**ROCKFORD BOARD OF EDUCATION  
INVITATION FOR BID ON SUPPLIES, MATERIALS, EQUIPMENT OR SERVICES  
FOR SCHOOL DISTRICT NO. 205  
ROCKFORD, ILLINOIS**

IFB No.        **23-02 Administration Building A/V Equipment**

DATE:         **June 22, 2022**

RE:            **ADDENDUM NO. 1**

# MIDDLE ATLANTIC BGR-3827

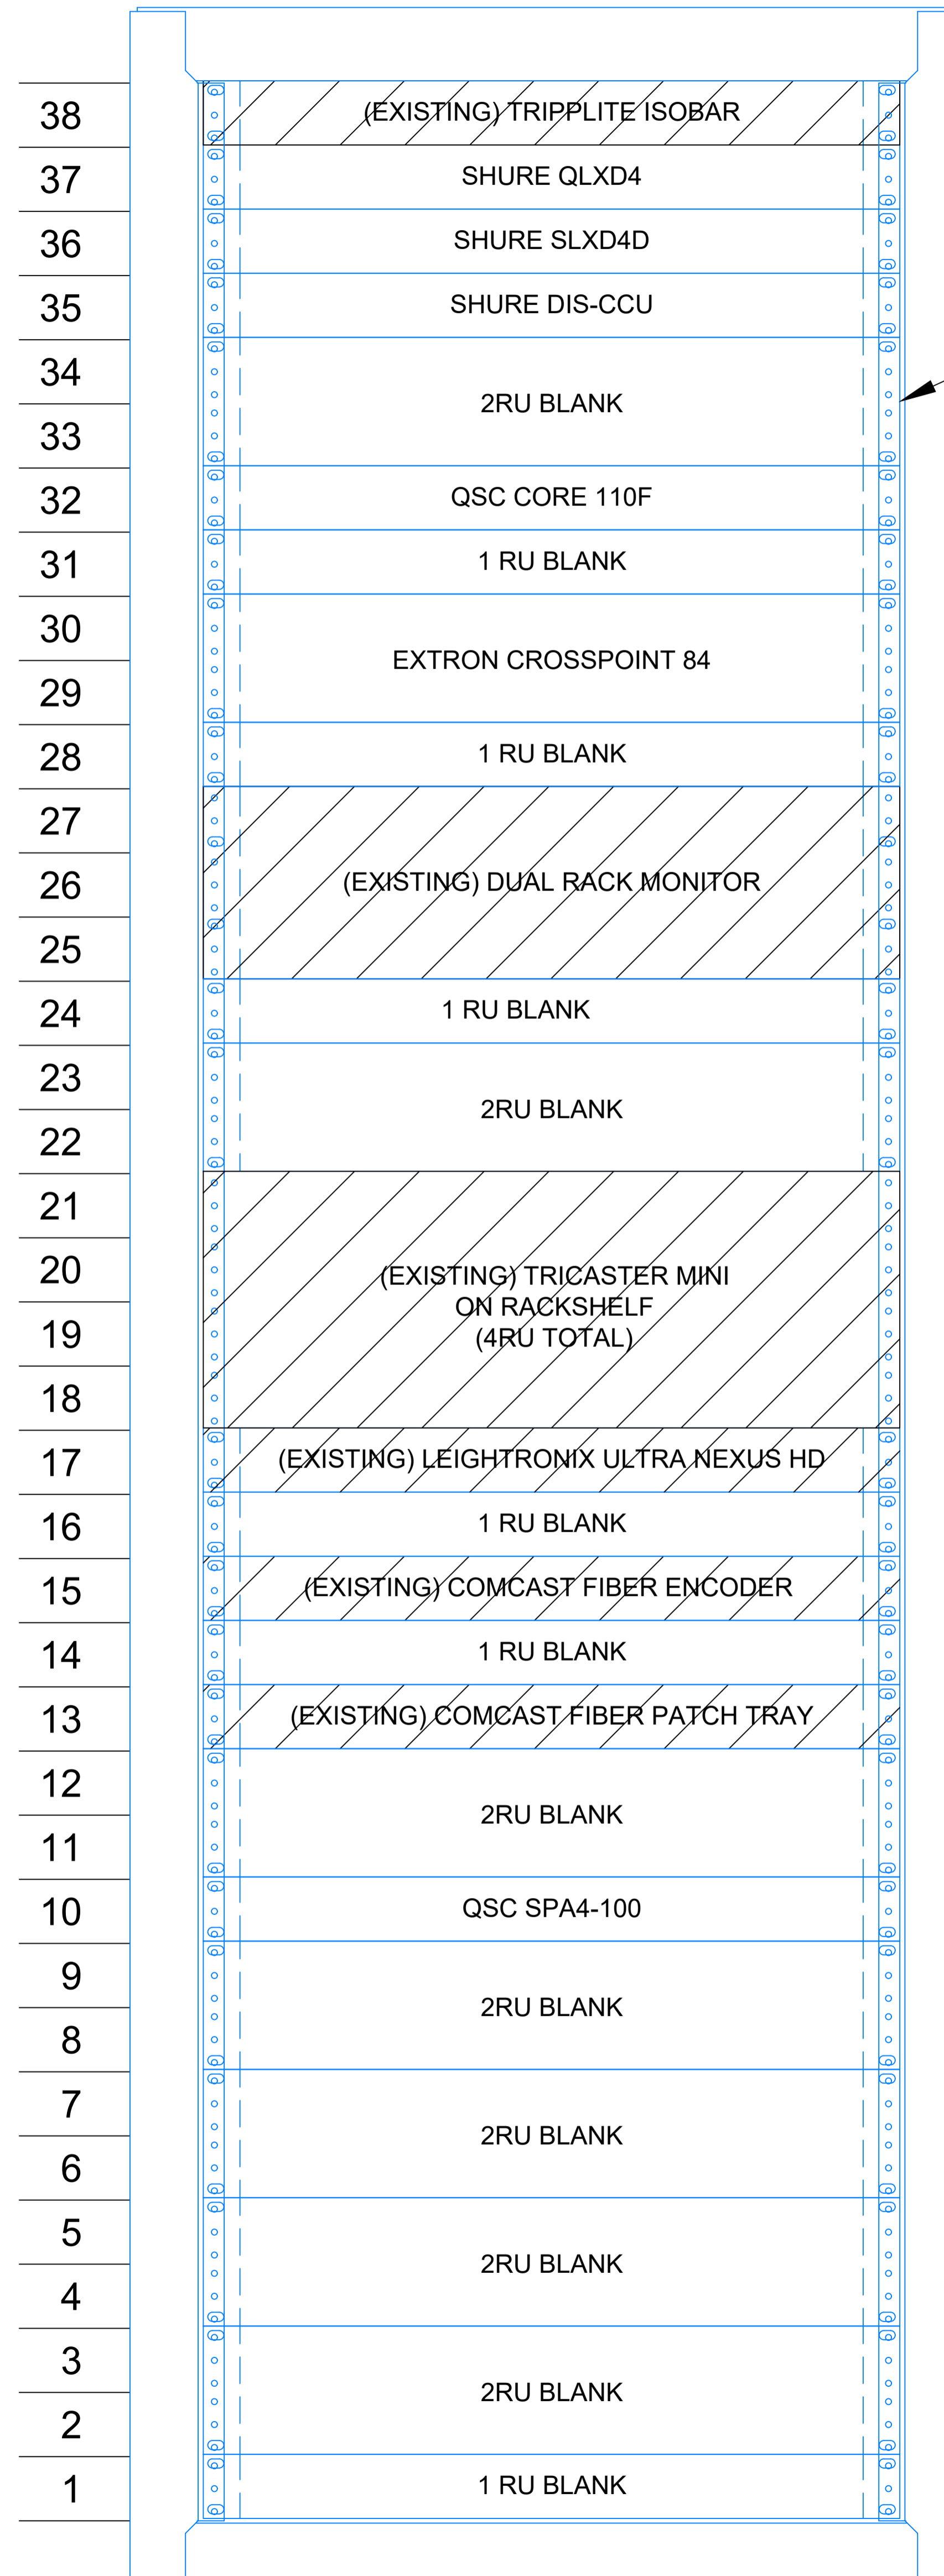
1. Please advise if this is a one-time purchase only.
  - a. Yes, this is a one-time purchase.
2. Please confirm this solicitation calls for only supply and delivery because line item 29 is installation.
  - a. This Invitation for Bid is for the supply, delivery, and installation of equipment.
3. Will there be an opportunity for a site visit or walk-through prior to bid submittal?
  - a. Yes, please contact the Purchasing department to schedule a site visit prior to the RFI due date of 12:00 PM June 28, 2022.
4. Please provide additional information about your existing systems.
  - a. Our current QSC control system is a QSC Core 110F.
  - b. Our current TriCaster video switcher is a TriCaster Mini HD-4SDI.
  - c. A schematic drawing of the 3<sup>rd</sup> floor control room is attached.
  - d. A layout of our renovated 2<sup>nd</sup> floor is attached.
